# Railyards Specific Plan Update, KP Medical Center, MLS Stadium, & Stormwater Outfall

Final Subsequent Environmental Impact Report

P15-040 | SCH No. 2006032058

October 2016

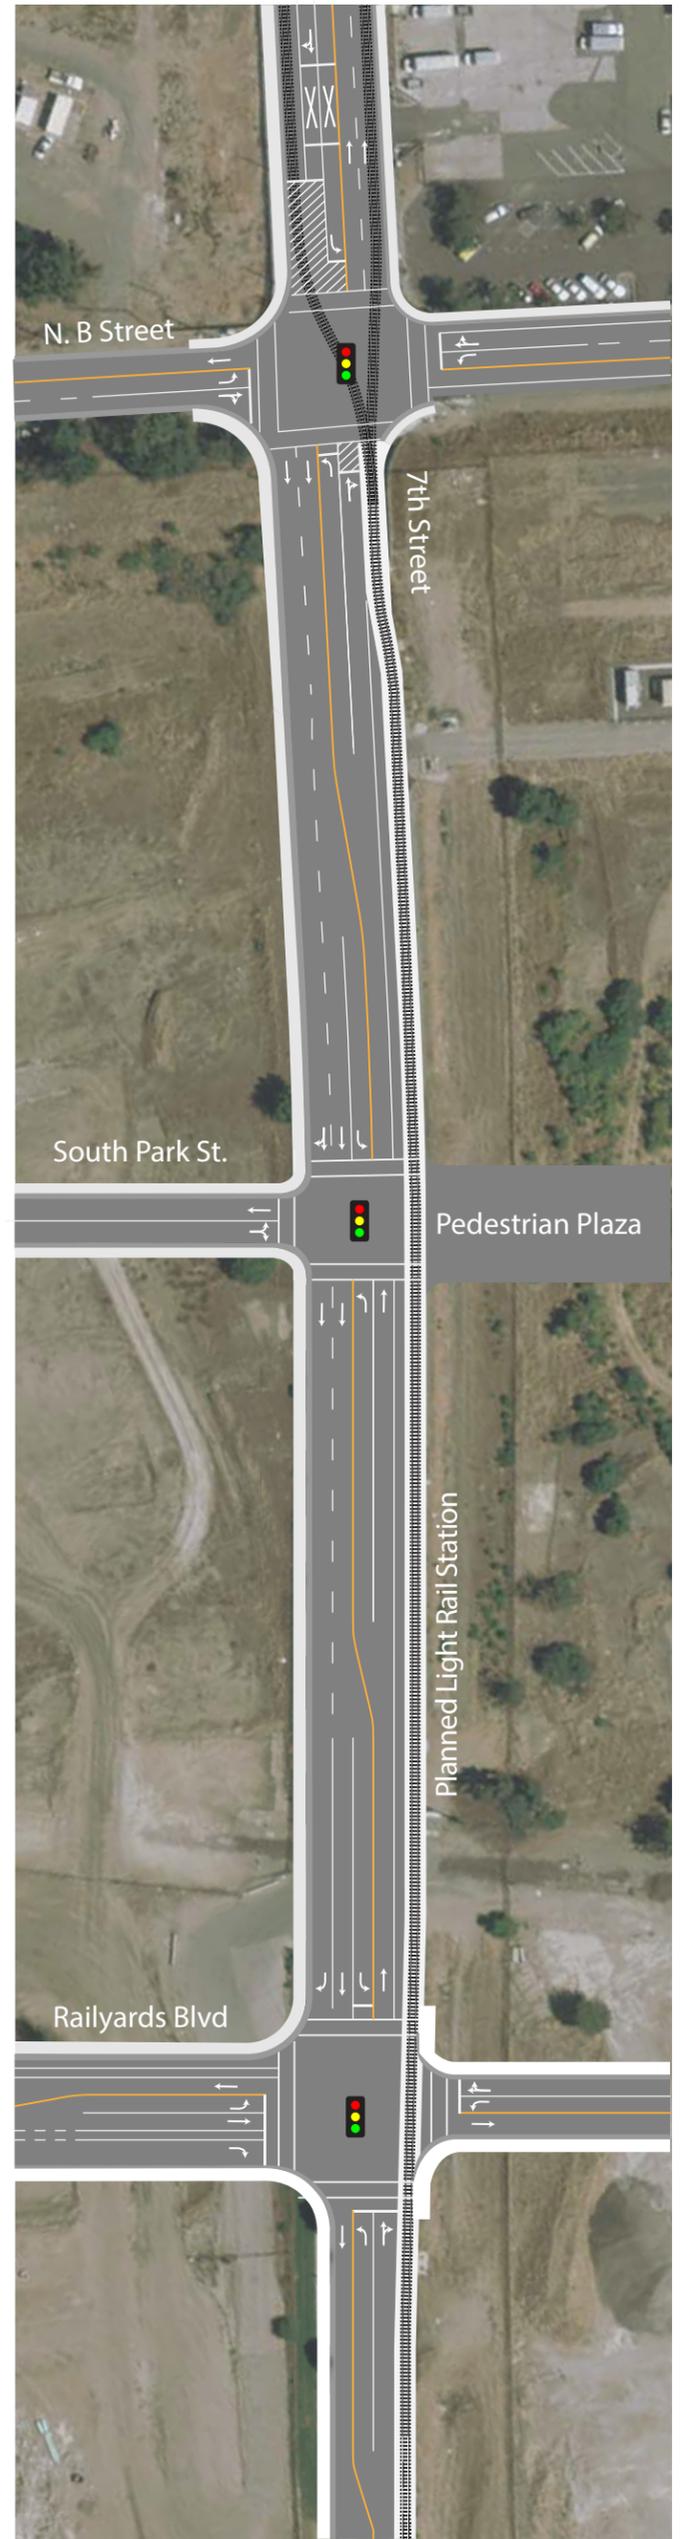
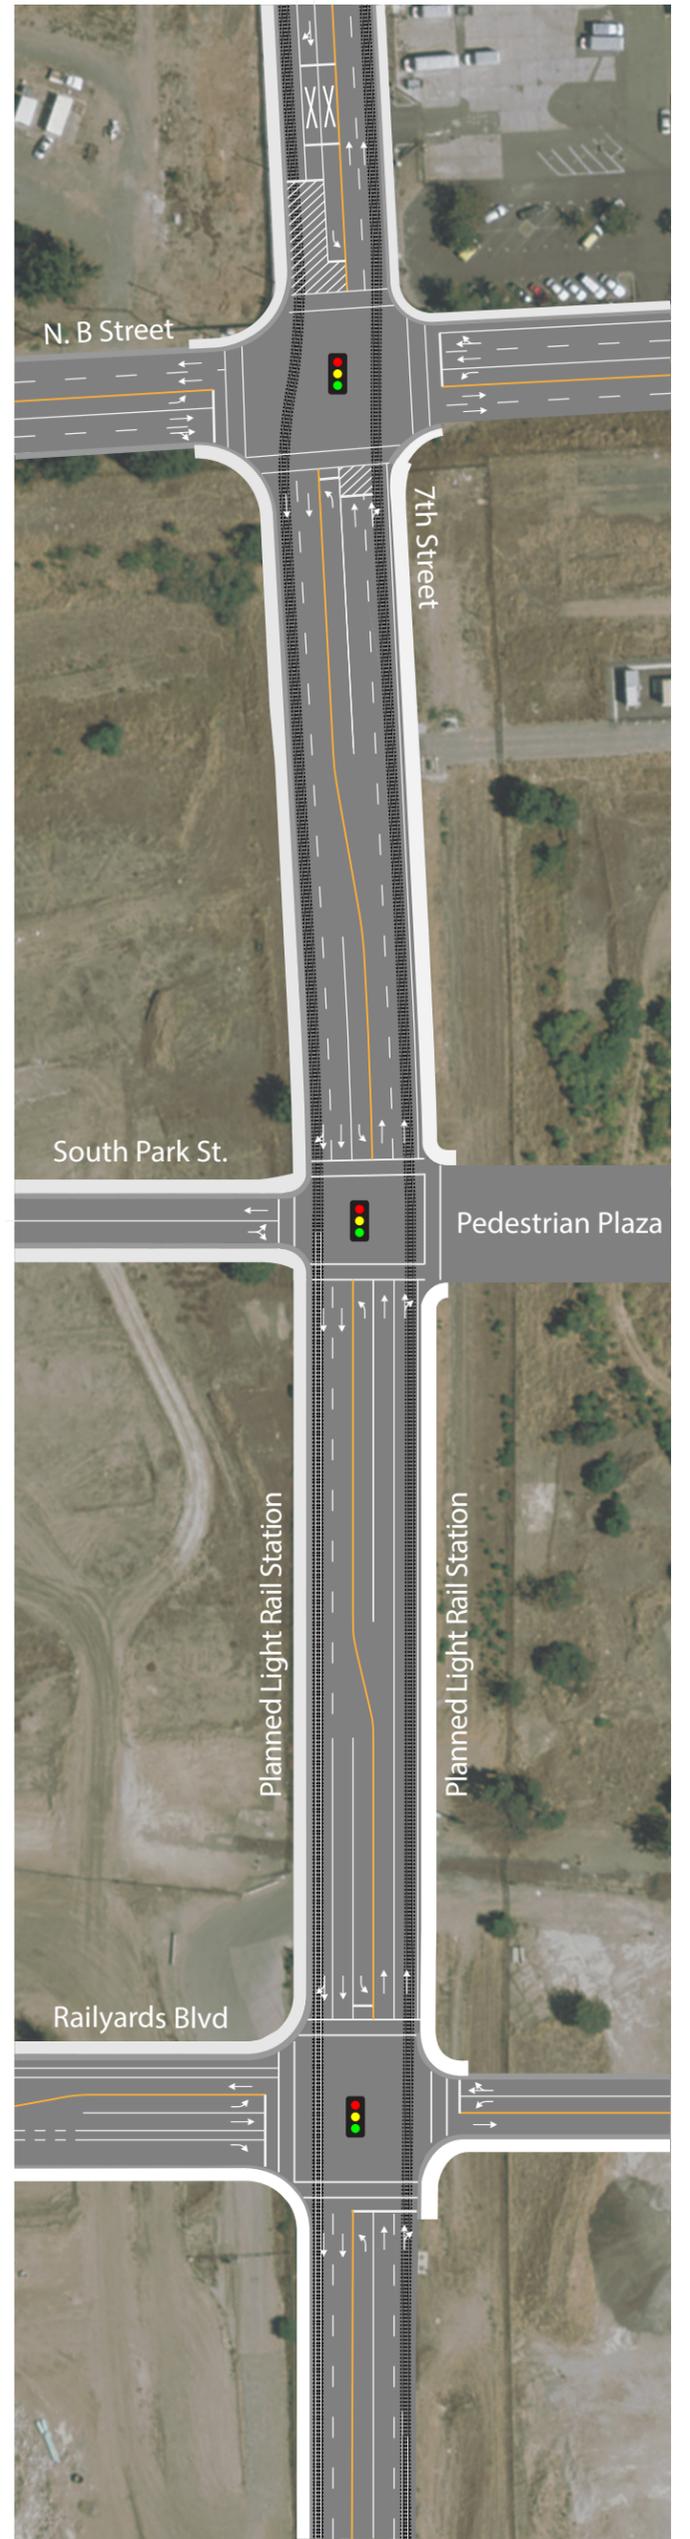
- b. Please show the Railyards station footprint on the SEIR's Figures 12-13 a and b.
  - c. Include construction of both Railyards station platforms and double-tracking of light rail on 7<sup>th</sup> Street as improvements being funded by the I-5 Subregional Corridor Mitigation Program fee.

Figure 4.12-13a, 7th Street Plan View, in Section 4.12, Transportation, of the Draft SEIR has been renumbered to Figure 4.12-13a. The figure is also revised to show the future light rail station planned on the east side of 7th Street north of Railyards Boulevard under Baseline Plus RSPU Conditions.

Figure 4.12-13b, 7th Street Plan View, in Section 4.12, Transportation, of the Draft SEIR has been renumbered to Figure 4.12-13b. The figure is also revised to show the future light rail station planned on the east and west sides of 7<sup>th</sup> Street north of Railyards Boulevard under Cumulative Plus RSPU Conditions.

- A8-2      Figures 12-13a and 12-13b have been renumbered to Figures 4.12-13a and 4.12-13b and included in Chapter 2, Revisions to the Draft SEIR. Additionally, Figures 4.12-13a and 13b have been revised to show the location of the planned light rail stations on 7<sup>th</sup> Street north of Railyards Boulevard. However, the station footprints are not shown because their dimensions are not known at this time. The primary purpose of these exhibits is to illustrate the planned widening and lane configurations of 7<sup>th</sup> Street under various scenarios, and not necessarily identify infrastructure for other modes of travel.
